**MONTGOMERY COUNTY HISTORIC PRESERVATION COMMISSION**  
**STAFF REPORT**

<b>Address:</b>	10304 Montgomery Avenue, Kensington	<b>Meeting Date:</b>	6/12/2024
<b>Resource:</b>	Primary Resource <b>Kensington Historic District</b>	<b>Report Date:</b>	6/5/2024
<b>Applicant:</b>	Jeff and Gloria Capron (Luke Olson, Architect)	<b>Public Notice:</b>	5/29/2024
<b>Review:</b>	Historic Area Work Permit	<b>Tax Credit:</b>	No
<b>Permit Number:</b>	1060765 REVISION	<b>Staff:</b>	Chris Berger
<b>PROPOSAL:</b>	Enlarged areaway and fenestration alterations.

**Figure 4: The previously approved site plan shows the areaway clouded in red.**

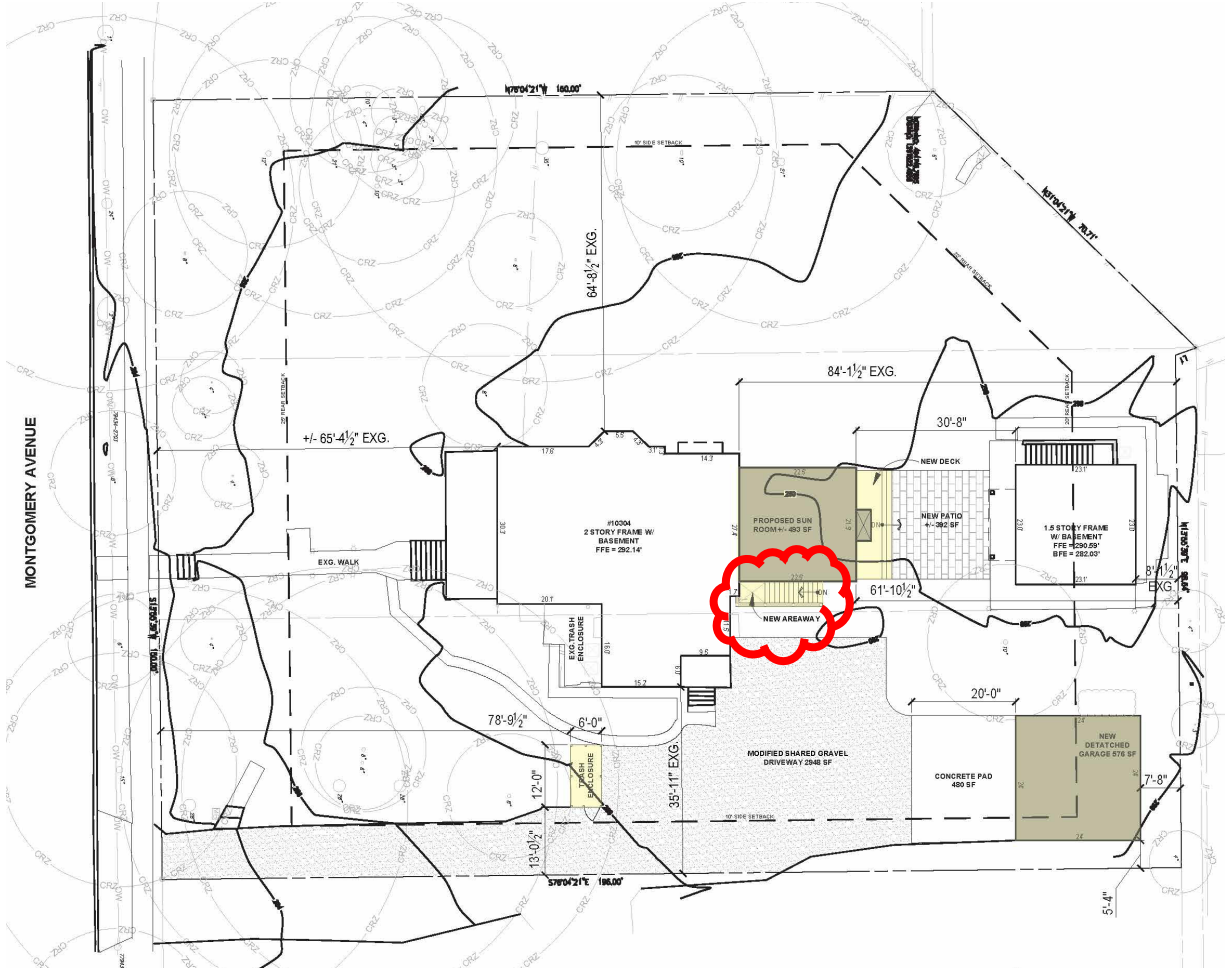
Staff supports the proposal to enlarge the proposed areaway and recommends approval. The applicants’ architect said the areaway needs to be enlarged to provide access to the existing basement in case the applicants cannot enlarge the basement as was previously planned. An existing window well will be replaced with a door, and the areaway will be enlarged approximately 60 square feet. The areaway will be surrounded by a composite guardrail to match the rail previously approved by the HPC. Staff recommends a condition that specifications are provided for the areaway door and railing.

1. The applicant must provide specifications for all proposed features, including doors, railings, and windows.
2. The infill siding in the proposed door opening needs to be either salvaged from other cuts in the house or be new wood siding that matches the profile, material, and finish.

Figure 7: The revised right-side elevation shows the existing, top, and proposed areaway and window converted into a door on the second floor clouded in red.

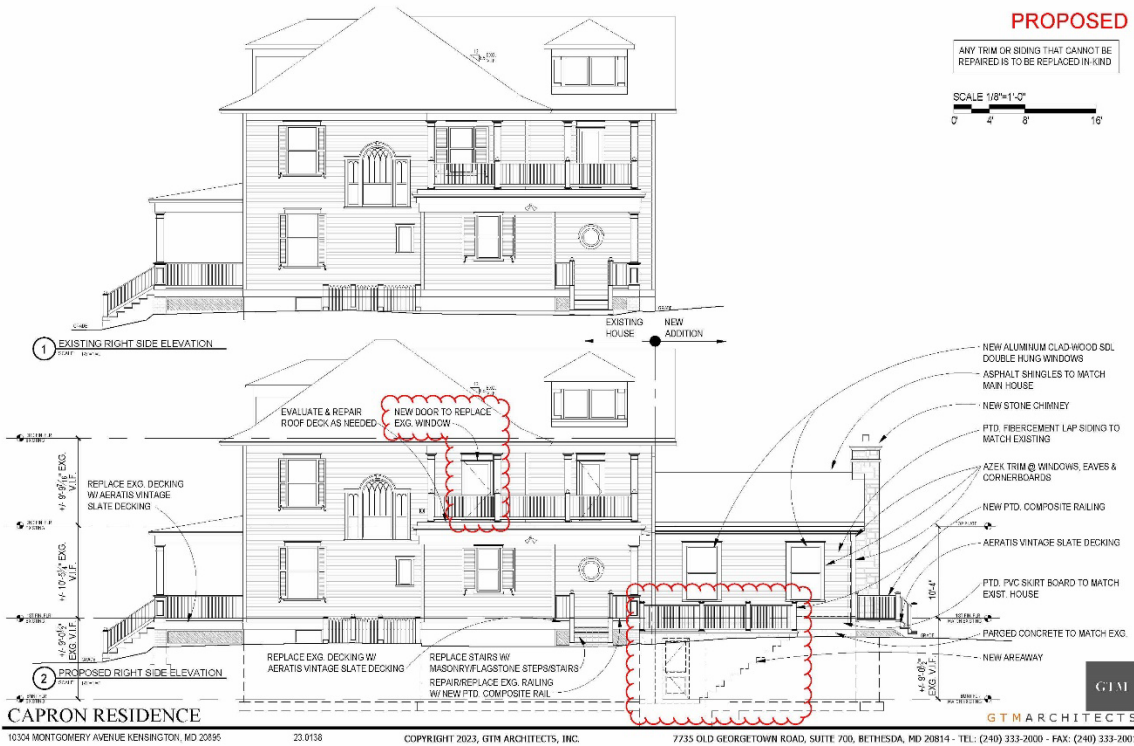
Staff supports the conversion of the second-floor window opening on the right-side elevation to a door and recommends approval. According to the applicant, the previously approved floor plan showed a door in that location, but the elevation instead showed a window. The new door opening will be shifted over from the window opening, and a portion of the existing window opening will be infilled with siding to match the existing. Staff encourages the applicant to retain the removed window and store it on site for potential reinstallation on the building. Staff recommends a condition that the new siding that will be installed to the left of the door should be salvaged from other locations on the house and/or it should match the material and profile of the existing siding exactly.

1 PROPOSED SITE PLAN  
 SCALE: 1:20

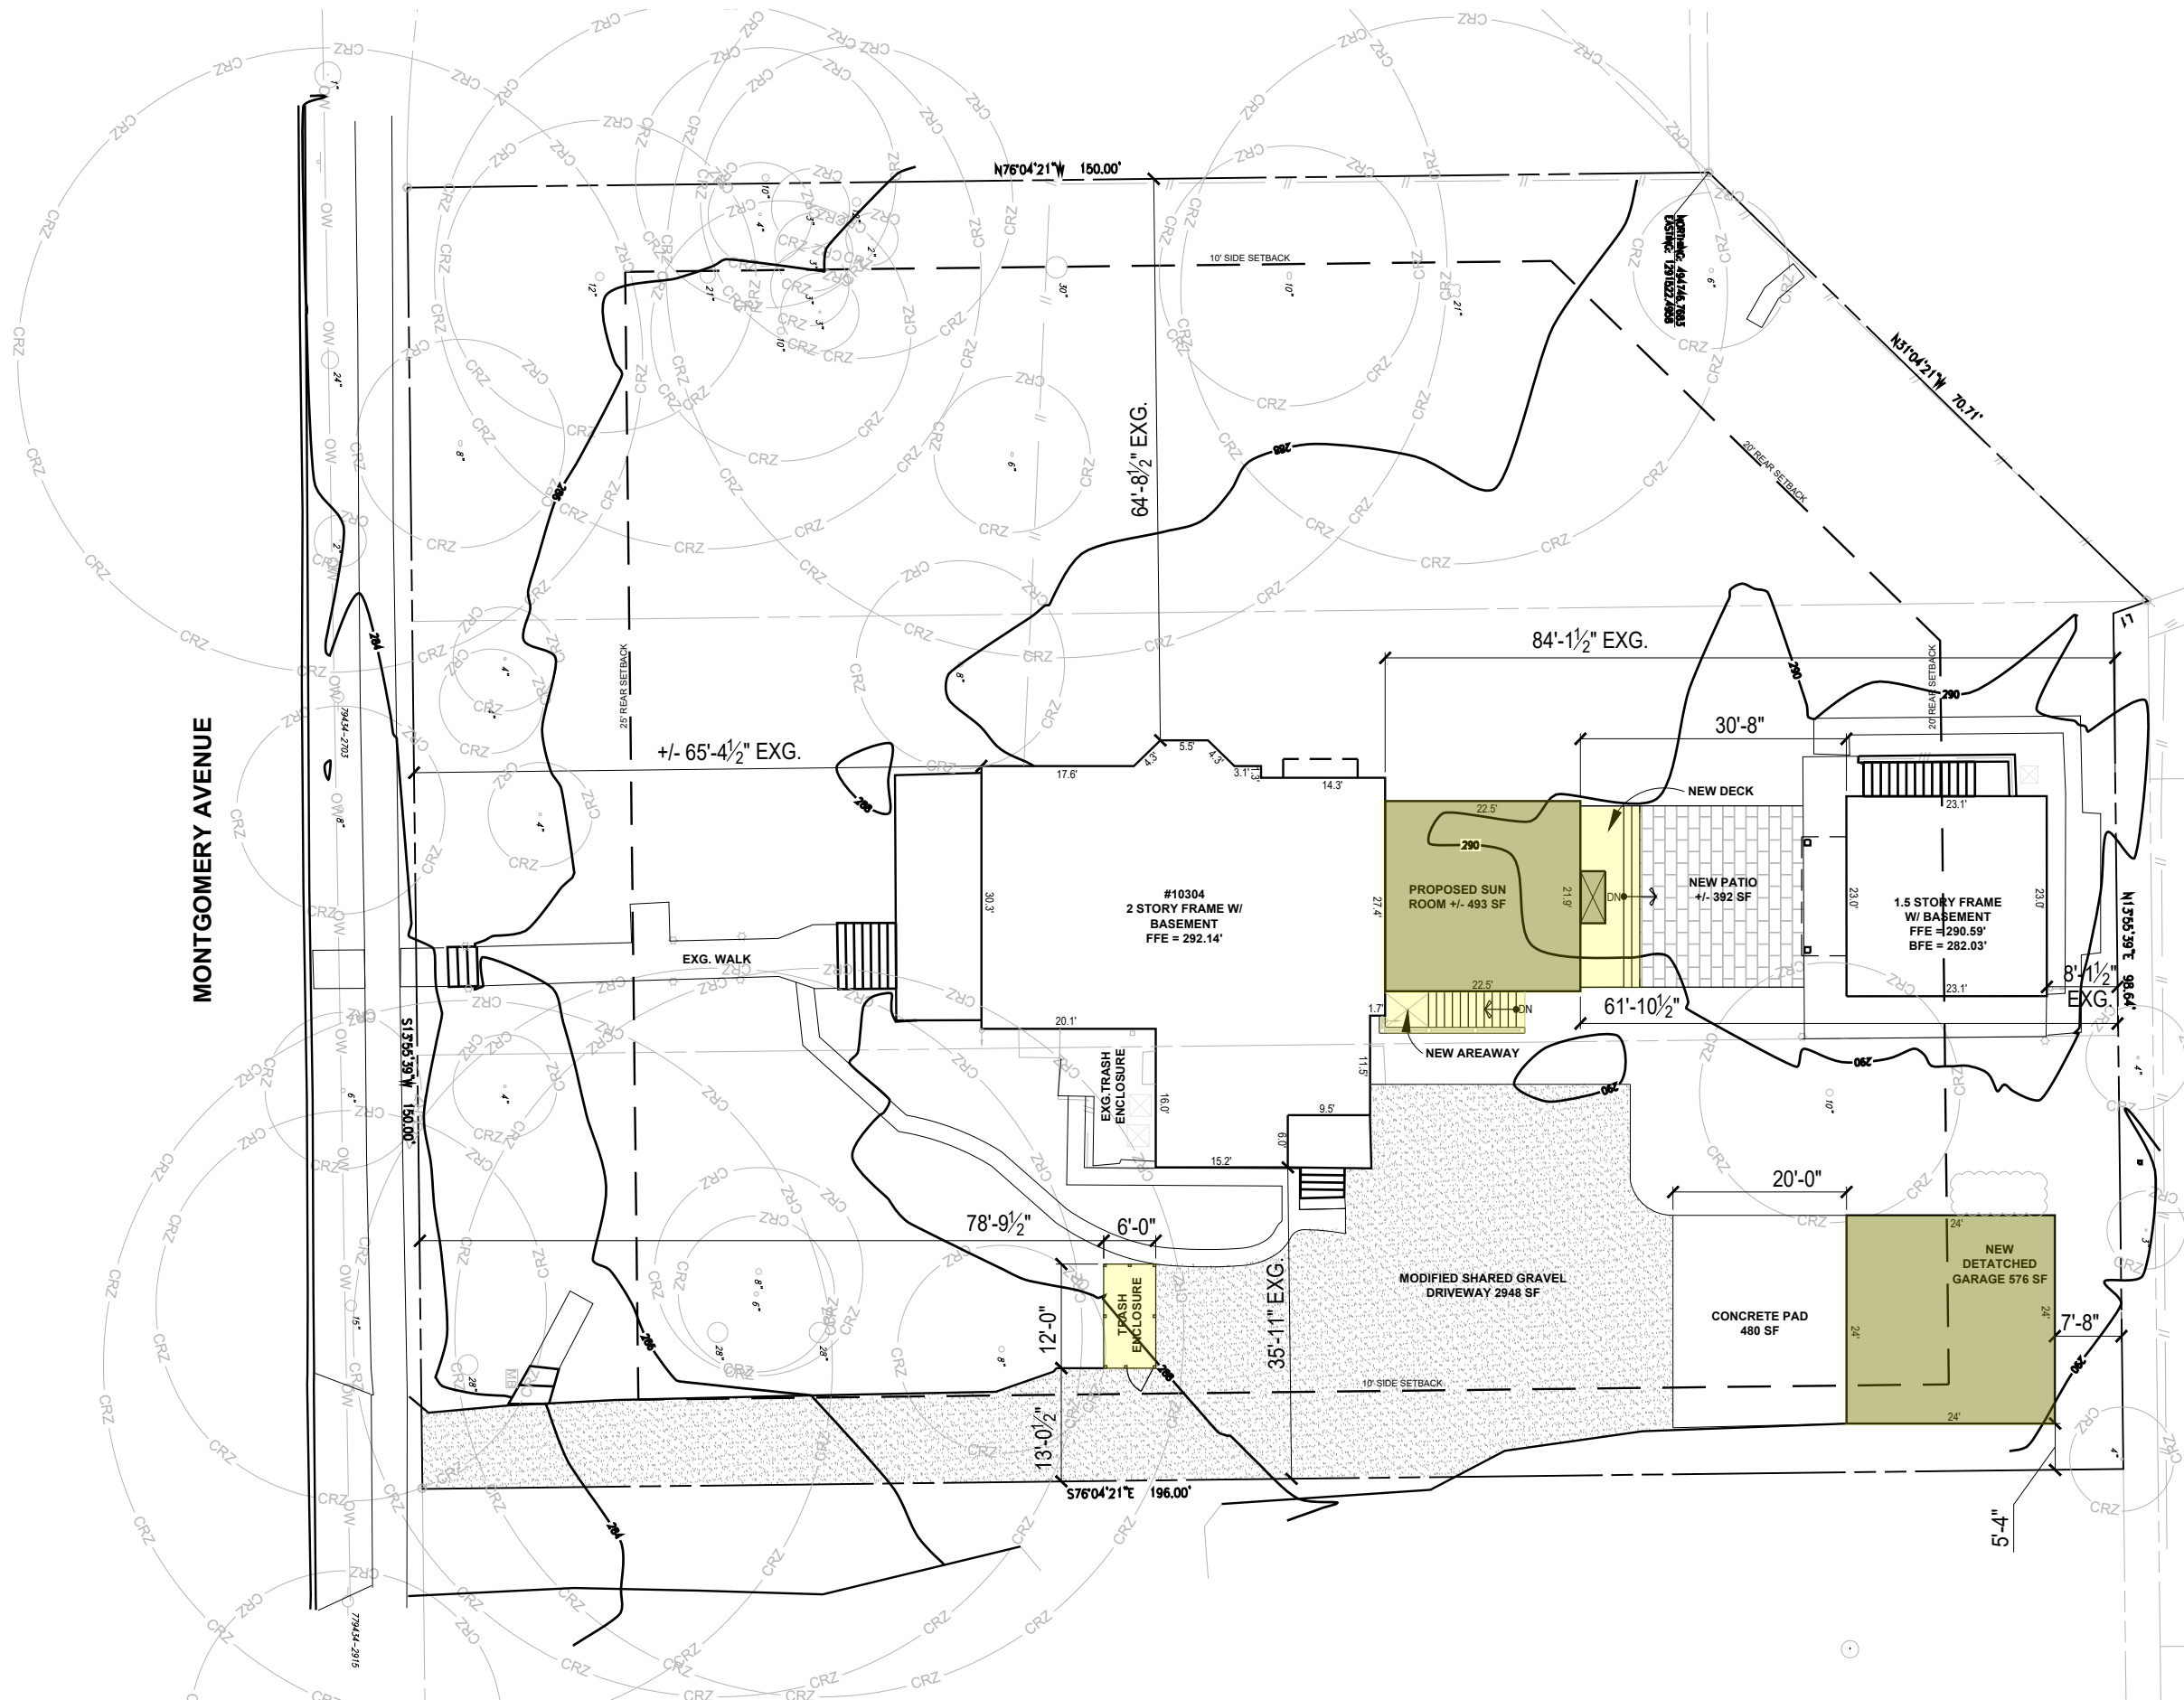
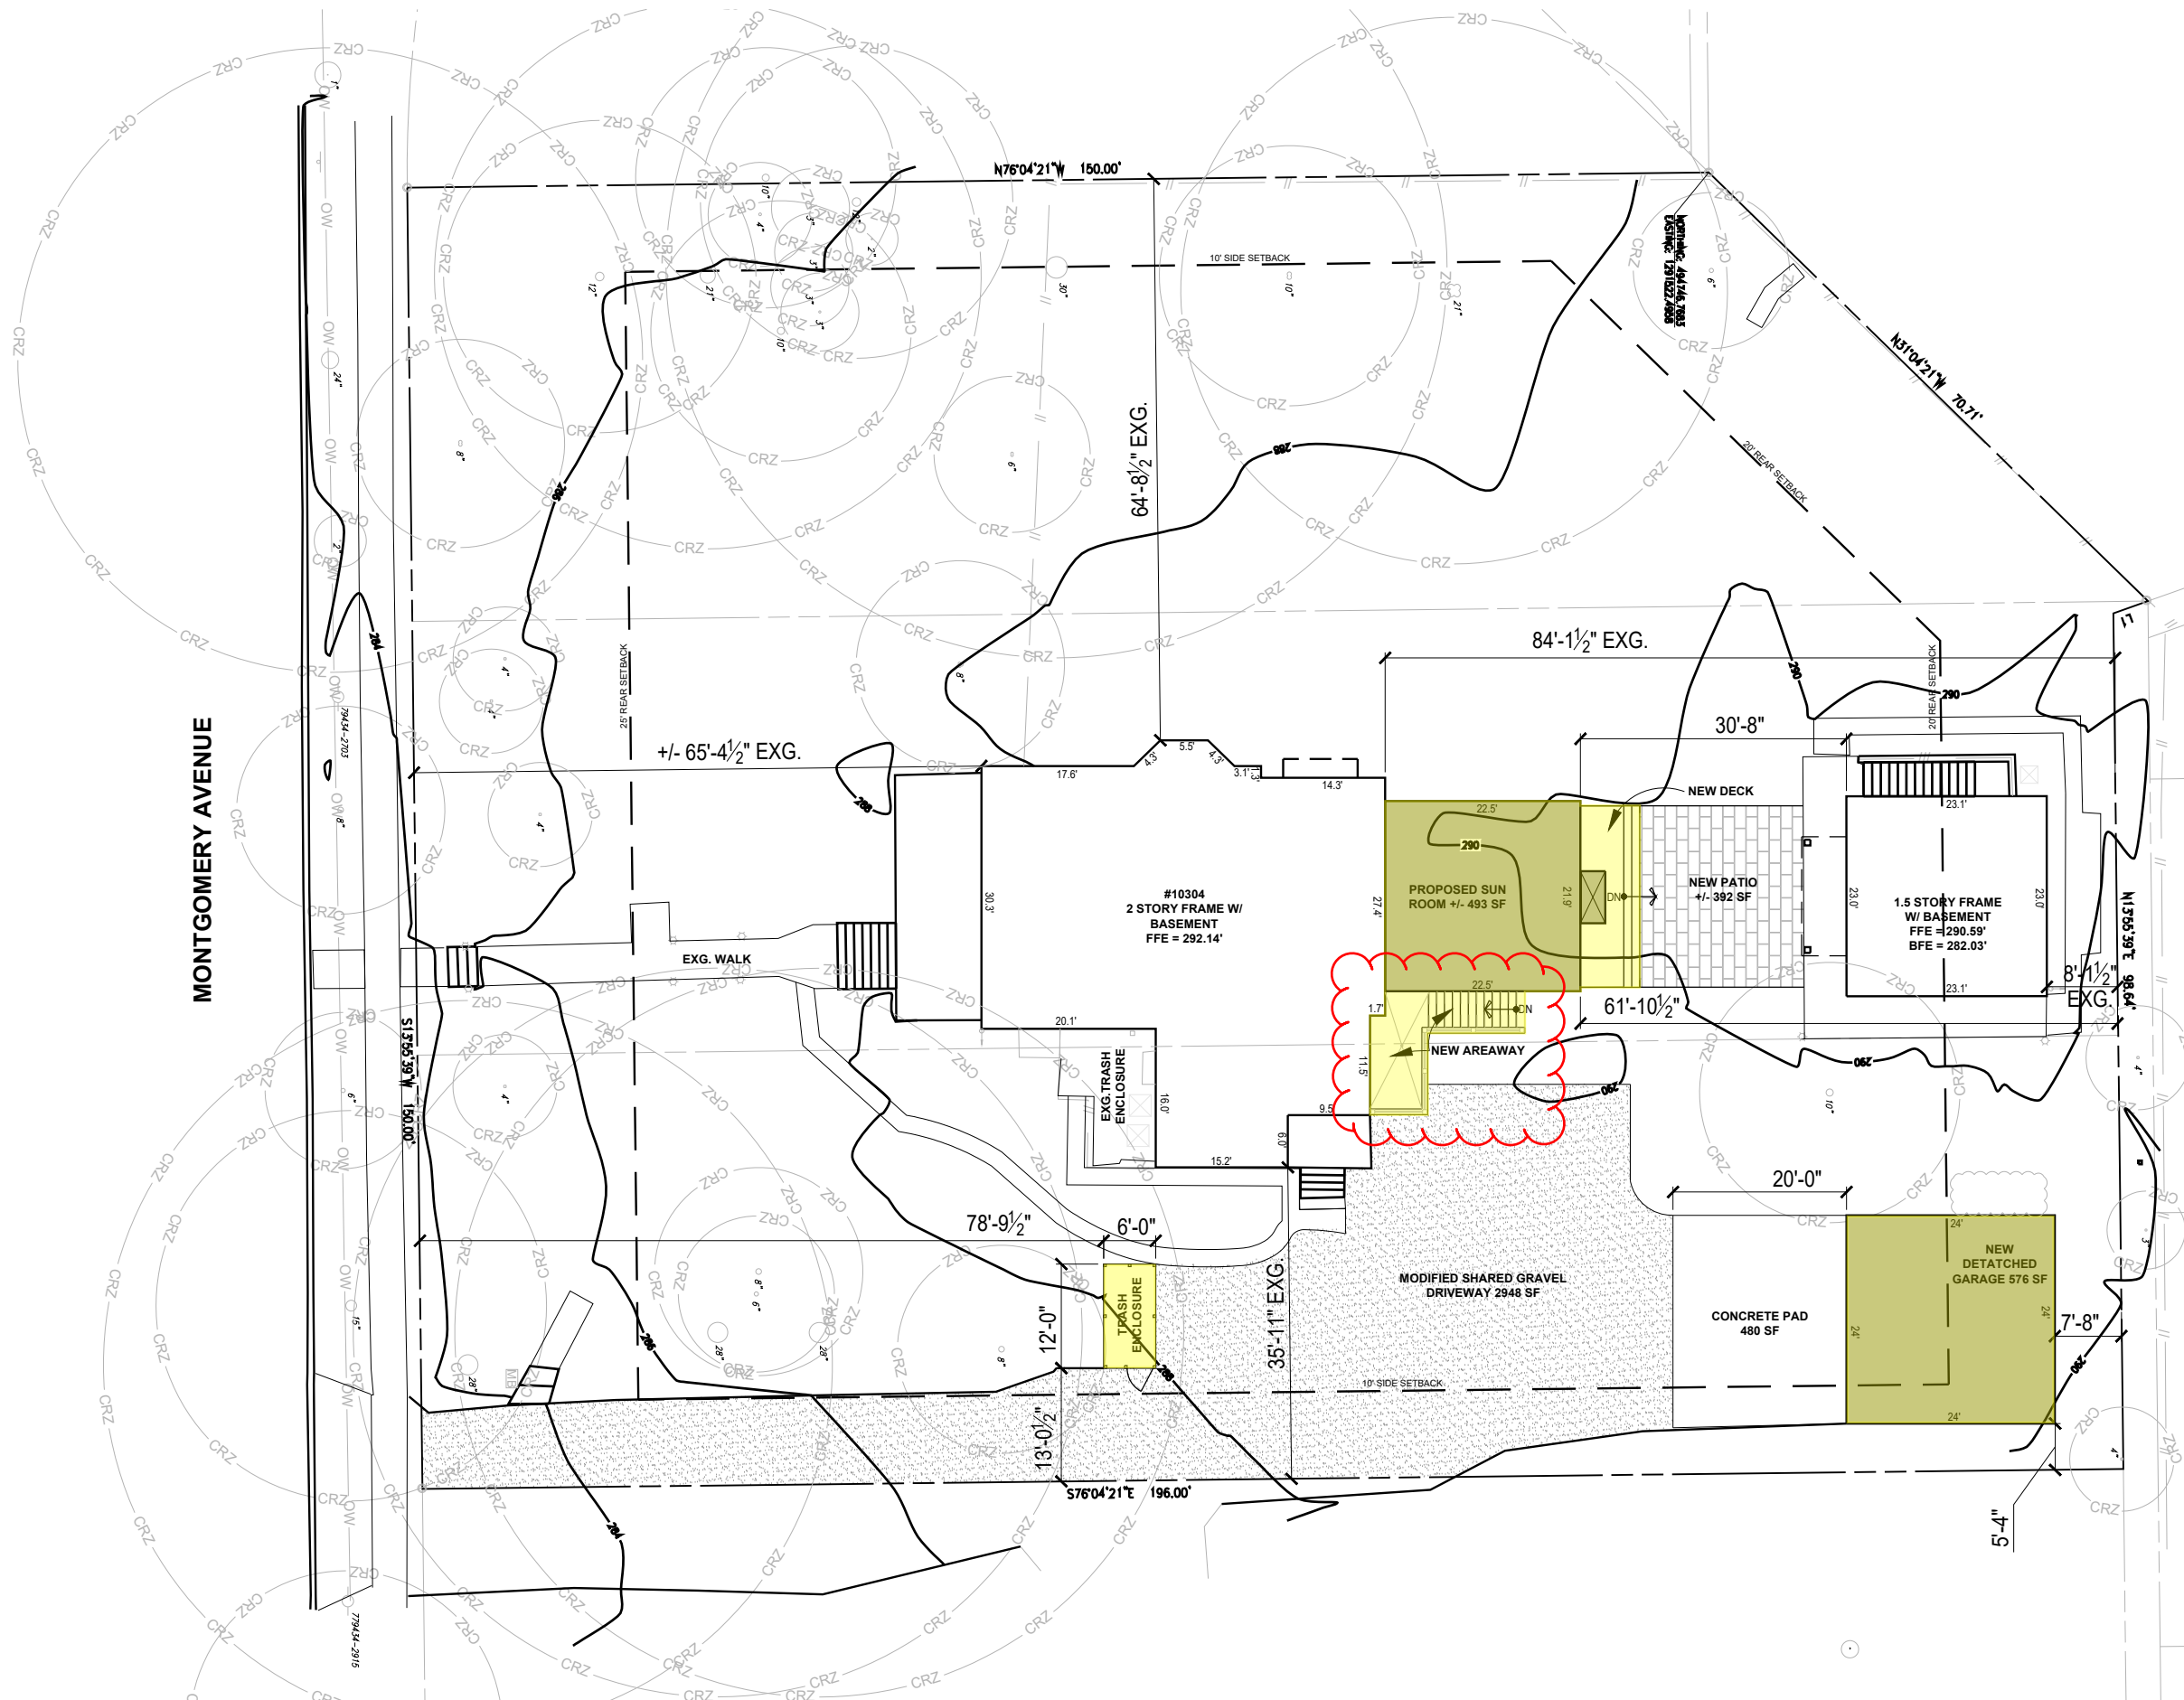
-enlarge the proposed basement areaway to provide an exterior entry door into the existing basement space in case they need to remove the full basement below the addition due to budget constraints
